In the Drawings

REMARKS

The Office Action mailed December 12, 2005 has been carefully considered. Reconsideration in view of the following remarks is respectfully requested.

FIG. 1

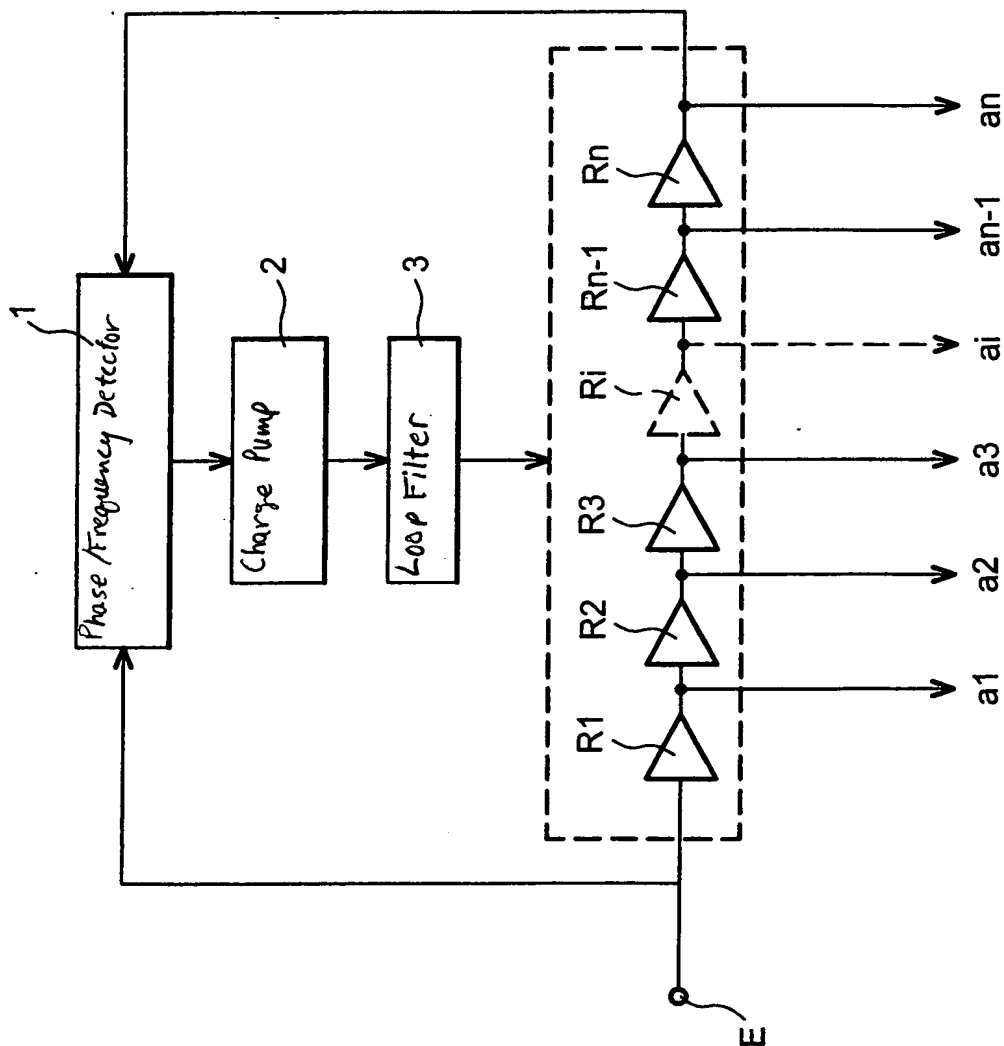
The attached replacement and annotated sheet(s) of drawings include changes to FIGS. 1-4, 5A and 5B. Specifically, FIGS. 1-4, 5A and 5B have been amended to provide descriptive legends to the boxes therein. Further, FIGS. 4 and 5B have been amended to add labels Ip1 – Ipn and Iq1 – Iqn consistent with the specification.

The drawing figures have been corrected in accordance with the Examiner's suggestions. Specifically, FIGS. 1-4, 5A and 5B have been amended to provide descriptive legends to the boxes therein. Further, FIGS. 4 and 5B have been amended to add labels Ip1 – Ipn and Iq1 – Iqn consistent with the specification. No new matter has been introduced. Approval of the corrections is respectfully requested.
